SUBJECT: ISSUANCE OF AMENDMENT NO. 71 TO FACILITY OPERATING LICENSE
NO. NPF-21 - WPPSS NUCLEAR PROJECT NO. 2 (TAC NO. 72924)

SAFETY EVALUATION BY THE OFFICE OF NUCLEAR REACTOR REGULATION
SUPPORTING AMENDMENT NO.71 TO FACILITY OPERATING LICENSE NO. NPF-21
WASHINGTON PUBLIC POWER SUPPLY SYSTEM
NUCLEAR PROJECT NO. 2
DOCKET NO. 50-397

Amendment No. 71
License No. NPF-21

Operating Region Limits of Specification 3.2.6
Figure 3.2.6-1

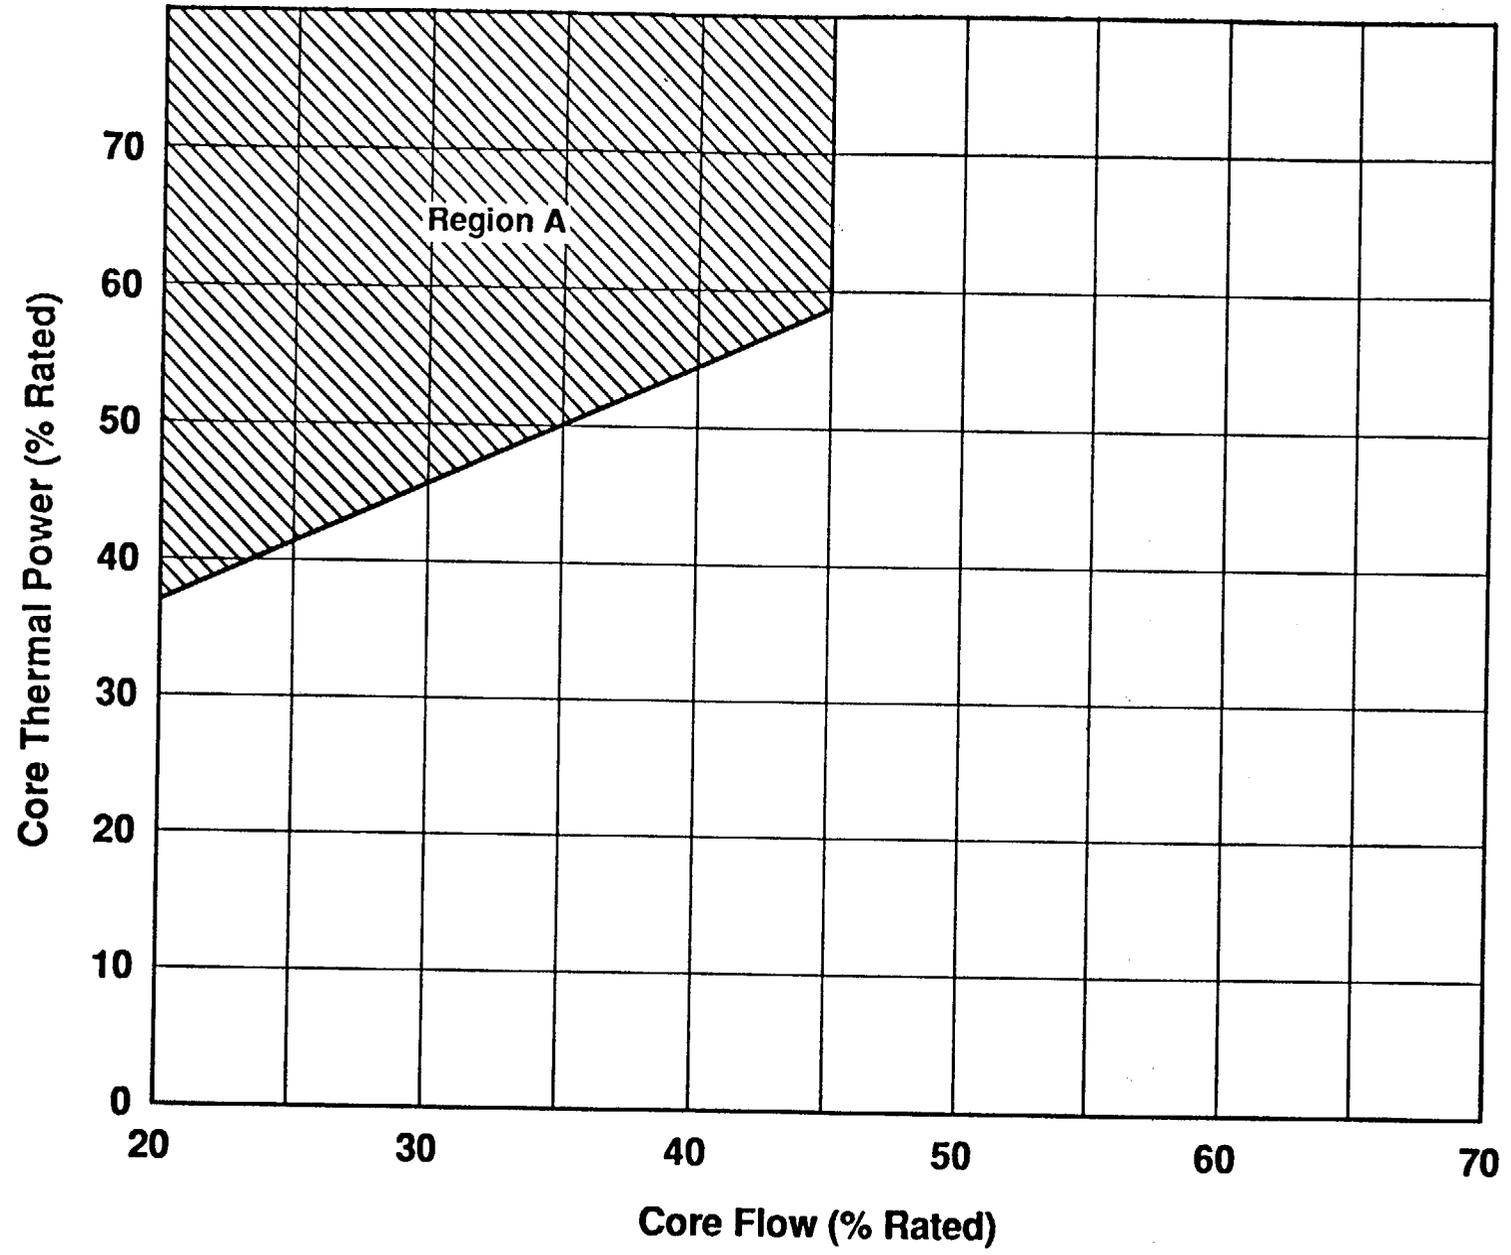
Specification 3.2.6 and Figure 3.2.6-1 provide, in both the current and proposed TS, a prohibited region which is larger than the IRSA region A. In the new TS, it extends to the 45 percent flow line, thus covering the upper part of IRSA region C. It can also extend below the 100 percent rod line since the lower boundary is the more conservative of the 100 percent rod line or a line below (ANF) calculated 0.90 oscillation decay ratio (DR). The proposed TS requires a manual scram exit from the region, in accord with the IRSA. These, and other wording changes of this Specification, are reasonable, generally conservative compared to the current Specification or IRSA, and are acceptable.

3.2.6 Operation with THERMAL POWER/core flow conditions which lay in Region A of Figure 3.2.6-1 is prohibited.

With THERMAL POWER/core flow conditions which lay in Region A of Figure 3.2.6-1, then as soon as practical, but in all cases within 15 minutes, initiate a MANUAL SCRAM.

4.2.6 The THERMAL POWER/core flow conditions shall be verified to lay outside Region A of Figure 3.2.6-1 once per 24 hours when operating in the region of APPLICABILITY.

Operating Region Limits of Specification 3.2.7
Figure 3.2.7-1

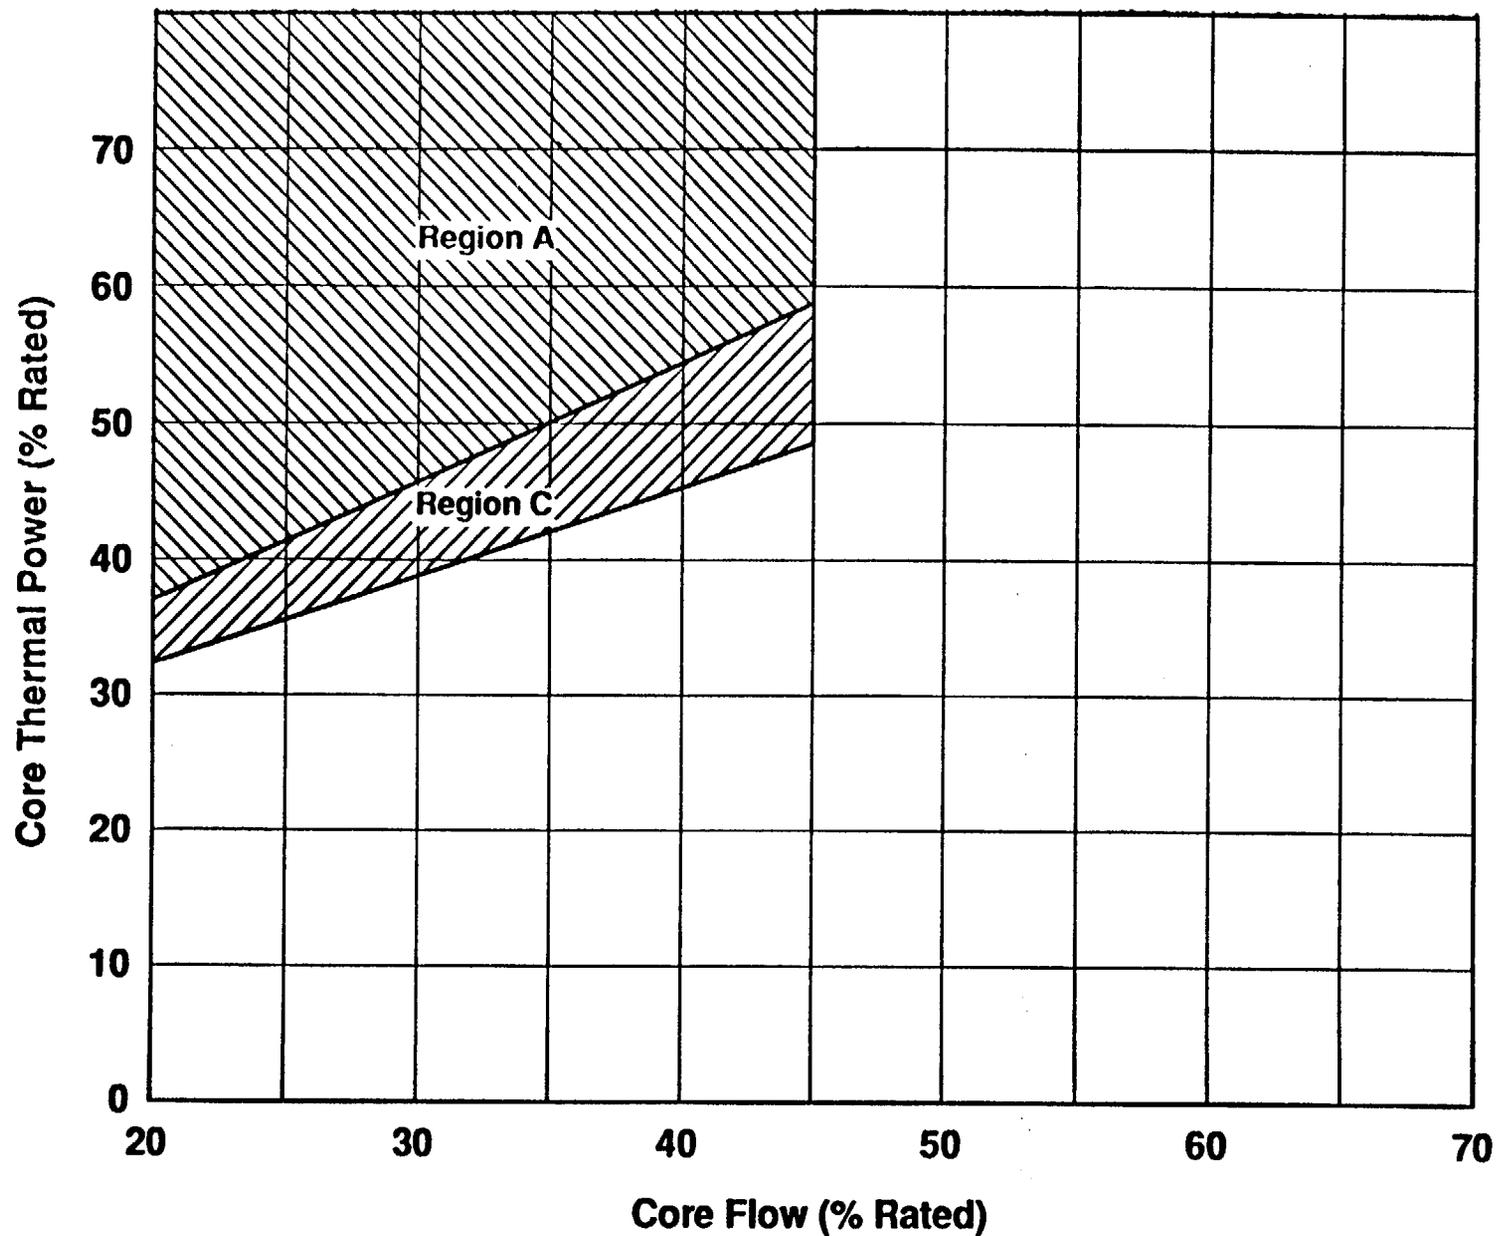
Specification 3.2.7 and Figure 3.2.7-1 provide a WNP2 region "C" (different boundaries than for IRSA region C) in which TLO is permitted if the ASMS is operable and indicating a DR less than 0.75. This region is directly below WNP2 region A and has a lower boundary on the 80 percent rod line. The region extends to the 45 percent flow line and covers approximately IRSA region B and the lower part of region C. The current TS permits operation in this region if the neutron monitoring system noise levels remain below criteria based on GE SIL 380 (Ref. 4) recommendations for surveillance. Operation is not permitted in the IRSA region B but is permitted in region IRSA C during startup, if necessary, with SIL 380 surveillance. Thus operation in Figure 3.2.7-1 region "C" is generally compatible with the current TS and to some extent with IRSA region C. It is not directly compatible with the required avoidance of operation in IRSA region B. Justification for this operation is based on ASMS surveillance.

3.2.7 The stability monitoring system shall be operable* and the decay ratio of the neutron signals shall be less than .75 when operating in the region of APPLICABILITY.

APPLICABILITY: OPERATIONAL CONDITION 1, with two recirculation loops in operation and THERMAL POWER/core flow conditions which lay in Region C of Figure 3.2.7-1.

Operating Region Limits of Specification 3.2.8
Figure 3.2.8-1

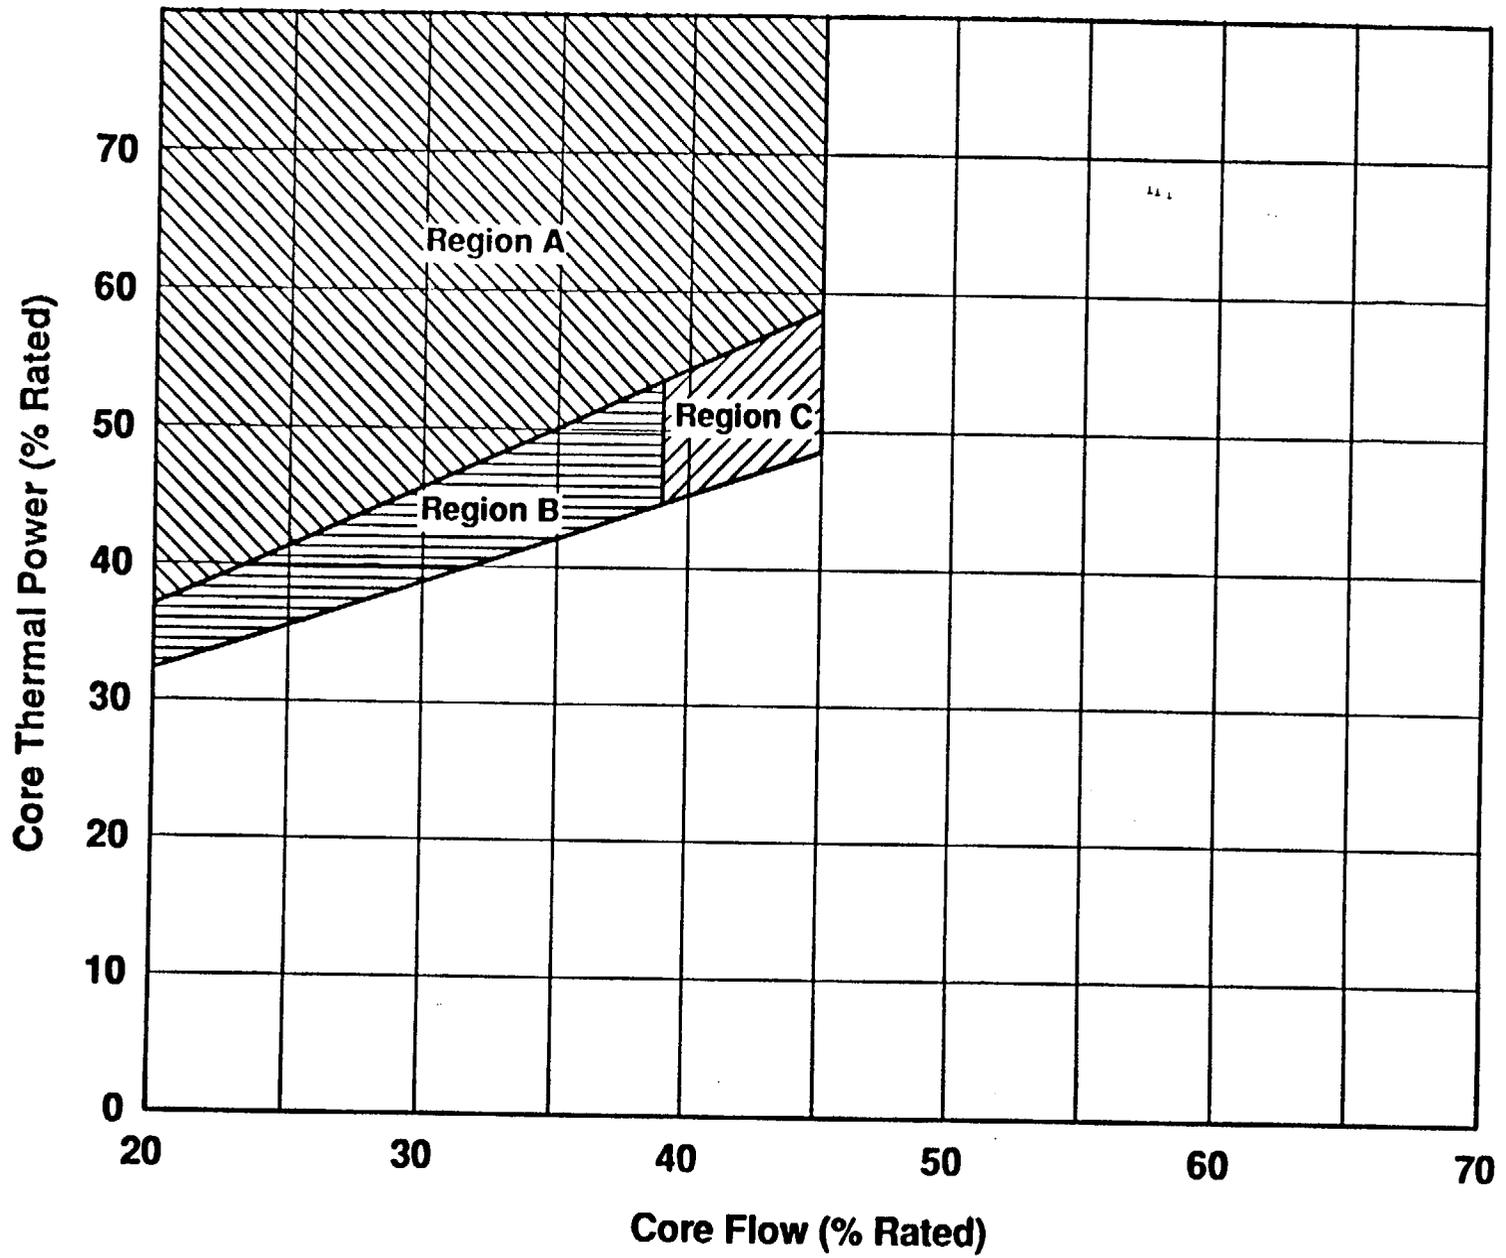
A new specification 3.2.8 and Figure 3.2.8-1 provide for a region with allowed operation in SLO. The specification defines a region "C" in Figure 3.2.8-1 which is a subregion of the TLO region "C" of Figure 3.2.7-1. This region includes only the 3.2.7-1 region "C" above 39 percent flow and thus involves the lower part of IRSA region C. Other than the more limited region area and the applicability to SLO, this TS is essentially the same as TS 3.2.7, and requires the same 0.75 DR limit and the same ASMS surveillance. Since the THS characteristics are similar for SLO and TLO in this region, this new Specification is also acceptable. The basis for acceptance is the same as discussed above for TS 3.2.7.

3.2.8 The stability monitoring system shall be operable* and the decay ratio of the neutron signals shall be less than .75 when operating in the region of APPLICABILITY.

APPLICABILITY: OPERATIONAL CONDITION 1, with one recirculation loop in operation and THERMAL POWER/core flow conditions which lay in Region C of Figure 3.2.8-1.

Operating Region Limits of Specification 3.4.1.1
Figure 3.4.1.1-1

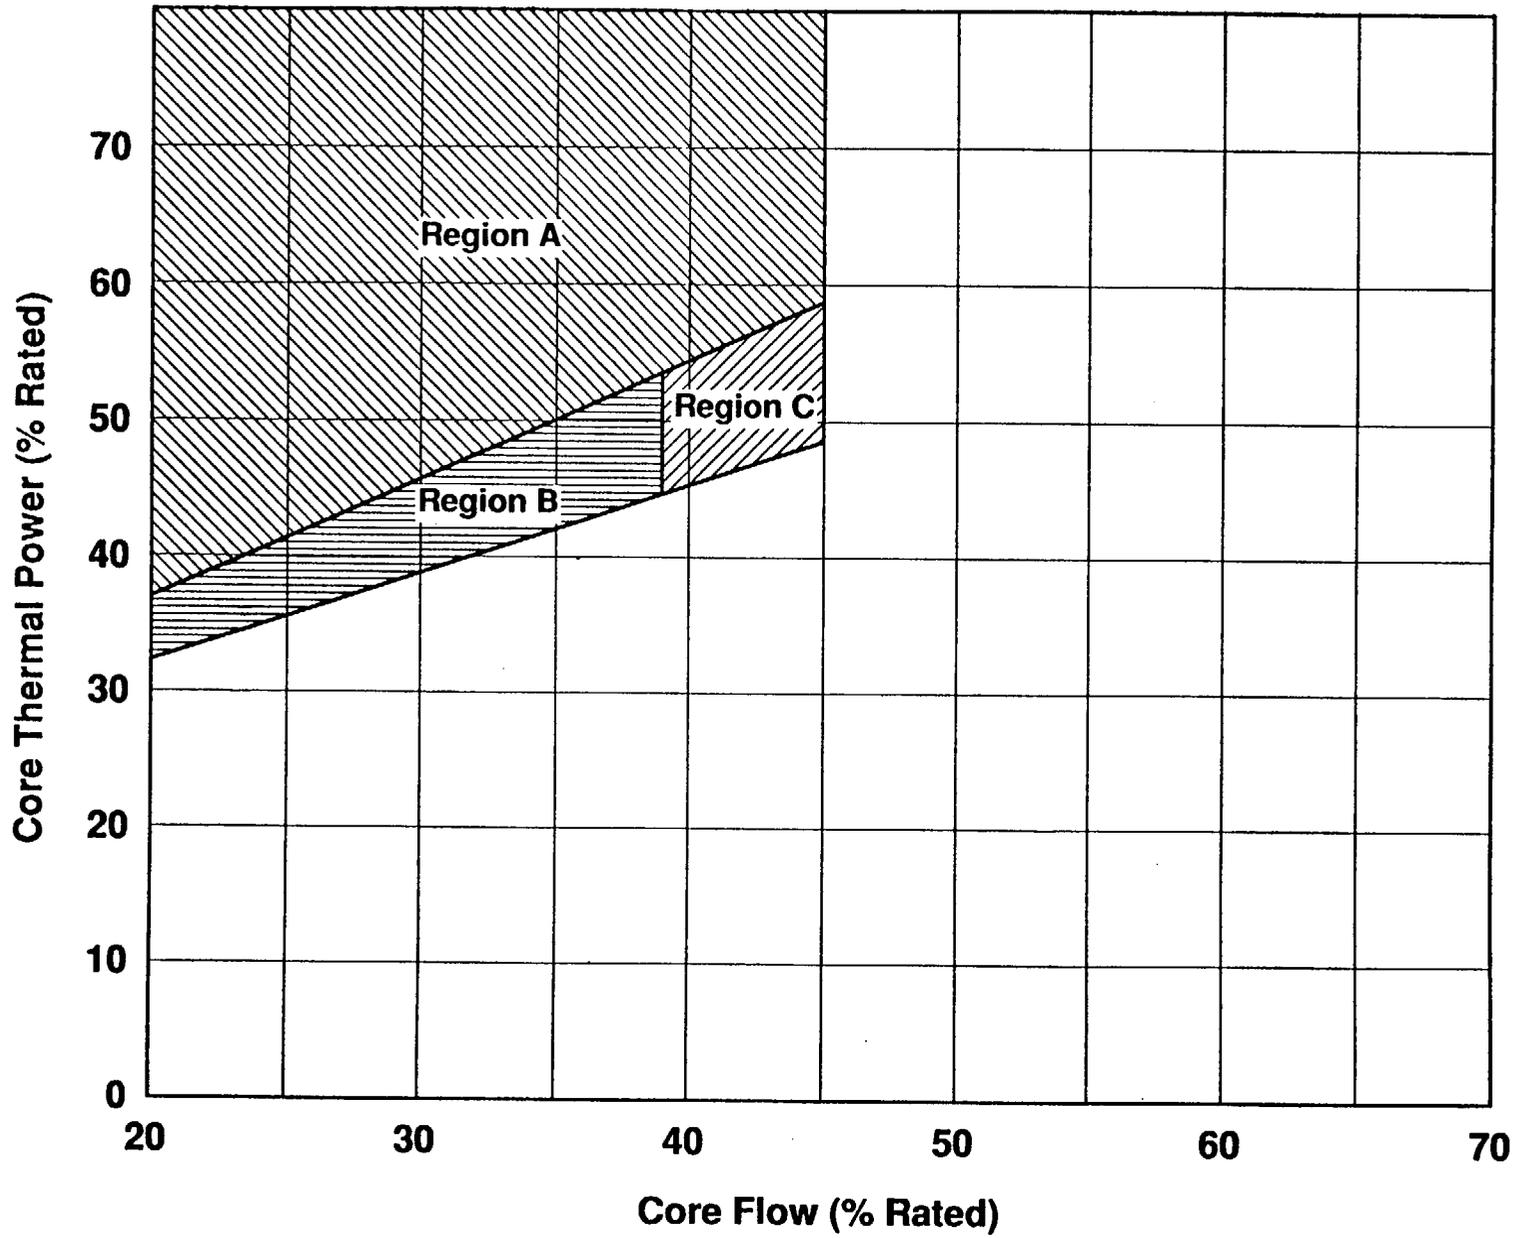
Specification 3/4.4.1 and Figure 3.4.1-1 contain most of the actions required when going to SLO. The only parts of the Specification which are proposed to be changed are those related to THS associated restricted regions and surveillance. The proposed TS prohibits SLO in WNP2 region "C" of TS 3.2.7 except for WNP2 region "C" of TS 3.2.8. Thus SLO is prohibited in (approximately) IRSA region B. This prohibited region is designated WNP2 region "B". Requirements for existing region "B", if entered, are provided. The changes and restrictions are compatible with those previously discussed for the TS changes, and are acceptable.

- a. With one reactor coolant system recirculation loop not in operation:
 1. Verify that the requirements of LCO 3.2.6 and LCO 3.2.8 are met, or comply with the associated ACTION statements
 2. Verify that THERMAL POWER/core flow conditions lay outside Region B of Figure 3.4.1.1-1.

With THERMAL POWER/core flow conditions which lay in Region B of Figure 3.4.1.1-1, as soon as practical, but in all cases within 15 minutes, initiate action to exit Region B by either decreasing THERMAL POWER with control rod insertion or increasing core flow with flow control valve manipulation. Within 1 hour exit Region B. The starting or shifting of a recirculation pump for the purpose of exiting Region B is specifically prohibited.
